Product Change Notice (PCN)

Subject: UV tape change for IGBT of 8inch unsawn wafer

Publication Date: 6/19/2023

EFFECTIVE DATE

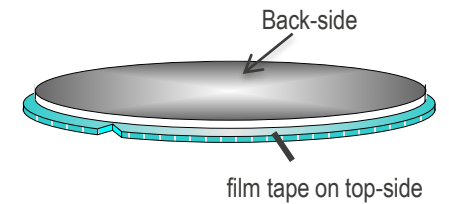
Shipments with a date after '23. 10. 01 on the Indication label A are UV tape changed products.

CHANGING POINTS OF TOP-SIDE FILM TAPE

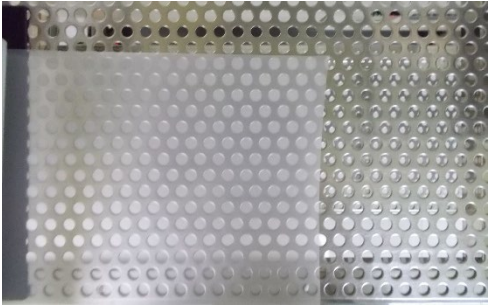
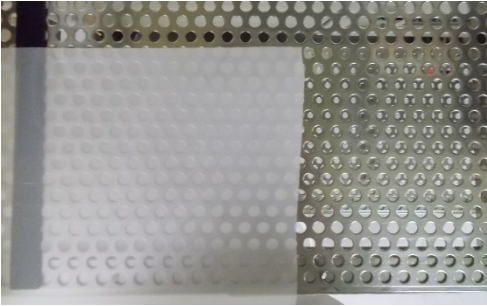
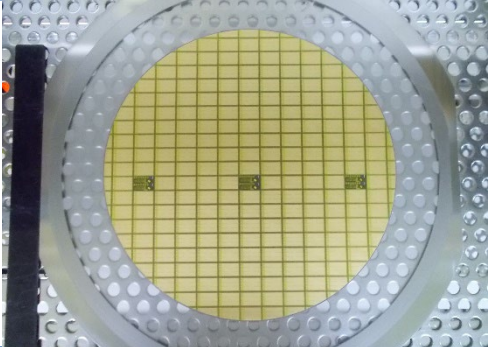
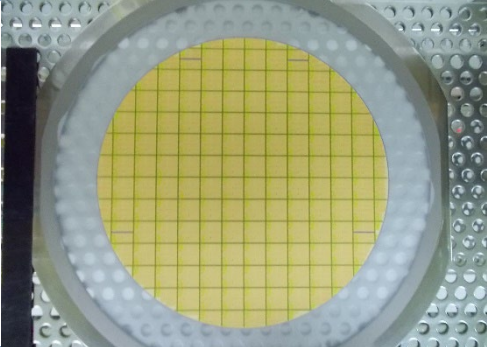
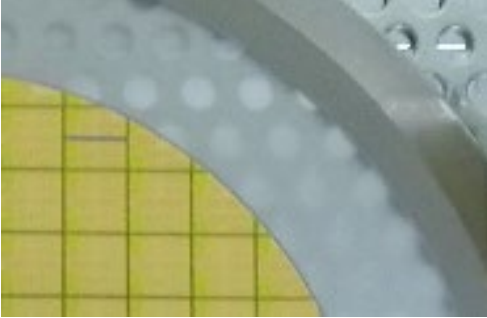
| item | Current | New |
| film thickness * | 150um | 130um |
| Color | White / high transparency | White / little transparency |
| Recommended storage period | Un-opened: 6months from packing date of label Opened: 7days from opened | 6months from packing date of label |

Evaluation chips in wafer(5chips)

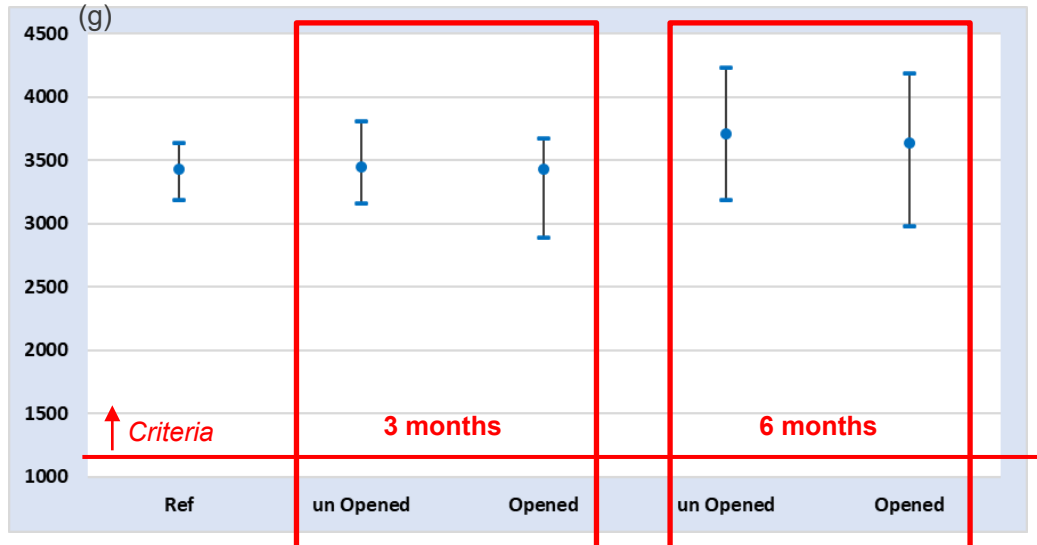
Bonding 500um(Emitter pads) & 300um(Gate pad) Al wire and evaluated below items.

Bonding Shear test (n=12)
speed:100um/s
height:50um

Wire peel test (n=12+1)

From i~iii results, wire bonding strength after more than 6 months storage is no problem.

No deterioration to initial value compared to reference is confirmed for all spec.
